Consultation Response

Project	Horton Road, Poyle		
Document Number	232244_CR_001	BWB Ref	232244
Author	Lucy Elmer MSc. MIOA	Status	Issue
Checked	Mike Barrett BSc (Hons), MIOA	Revision	P01
Approved	Luke Smith BEng, MIOA	Date	07/07/2023

Response to Environmental Health Comments – Noise

Figure 1: Proposed acoustic barrier location

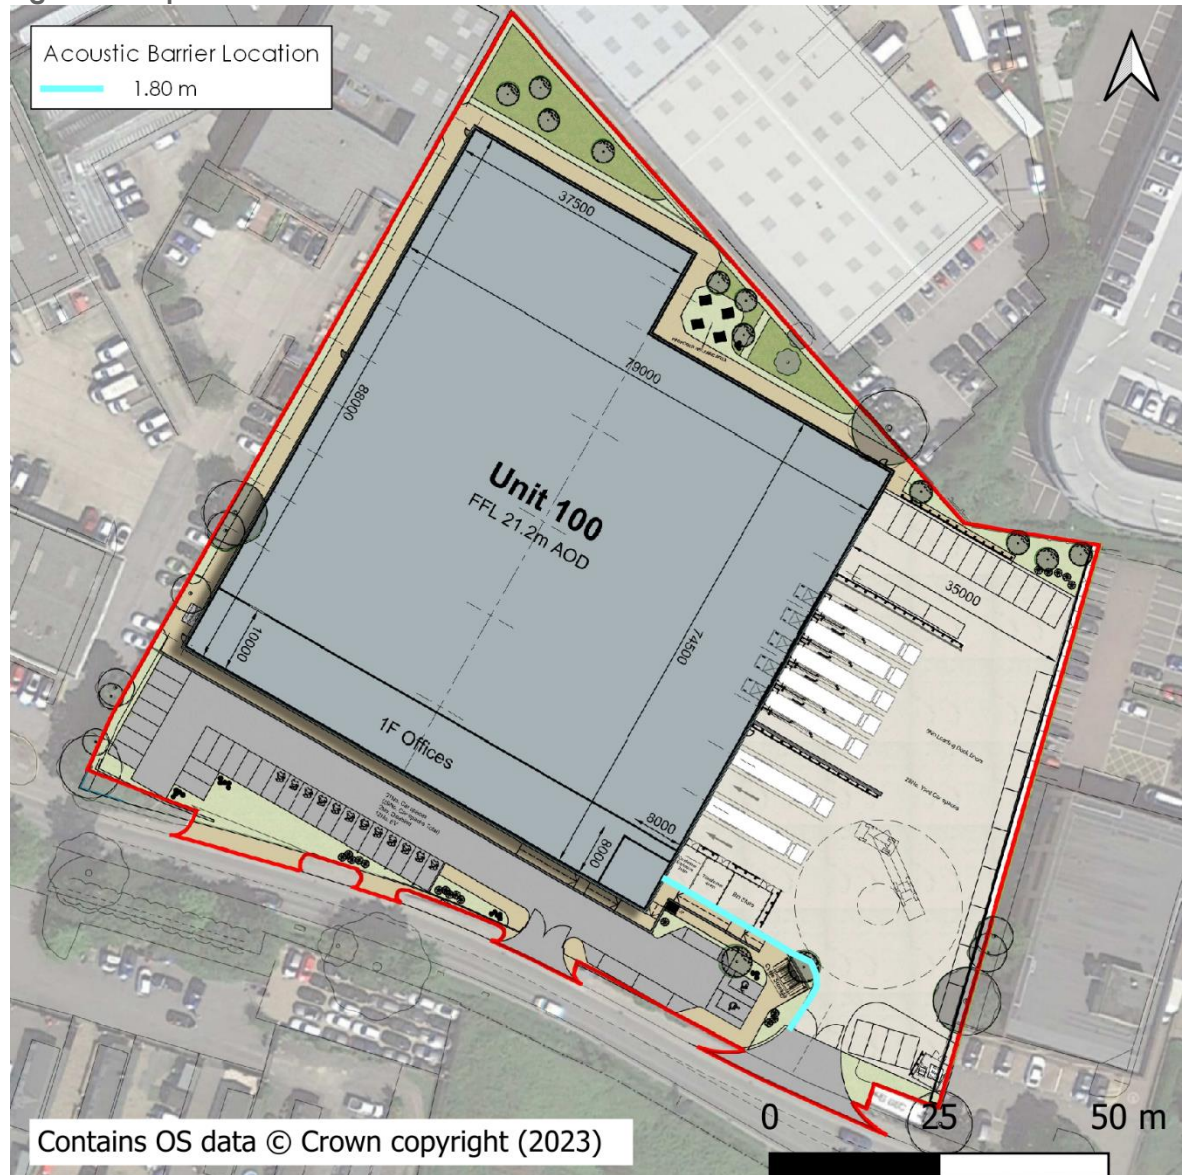
To address the 7dB above background exceedance, an acoustic barrier has been proposed which is located adjacent to the plant compound. Implementation of this barrier reduces the night time noise impact by 2dB, resulting in mitigated noise levels 5dB above background noise levels. This would typically be deemed unacceptable in regards to noise impact. It is strongly recommended that the applicant seeks additional mitigation options to reduce the noise level further. Options may include:

- Providing additional acoustic barriers alongside the cycle store area to reduce noise transmission from the service yard.
- Restricting use of the level access doors to one per delivery during the night.
- Undertaking continuous noise monitoring during operation to proactively control noise.

Although it is explained in the report that the noise level is likely to be acceptable due to context and the existing ambient noise level being above the background noise level, the applicant should demonstrate that they have taken every practicable measure to reduce their noise levels as far as possible. As such, it is strongly recommended that the above mitigation measures are explored to determine whether the noise level can be reduced further. In the past, the LPA has accepted a 2dB above background noise level therefore the applicant should endeavour to reduce noise levels to meet this criteria as a minimum.

To address the above during the night-time on a weekend, the benefit afforded by the acoustic barrier and the specific on-site operations have been explored further to reduce the noise impact at NSRs as much as practicable.

The original noise assessment assumes that there could be two fork-lift trucks operating at the same time at both the level access doors. This number has been reduced to one for the night-time weekend period as it is considered unlikely that both level access bays would be in use at the same time. In addition, the 1.8m high acoustic barrier has been extended to wrap around the cycle area, as shown in **Figure 1** below.
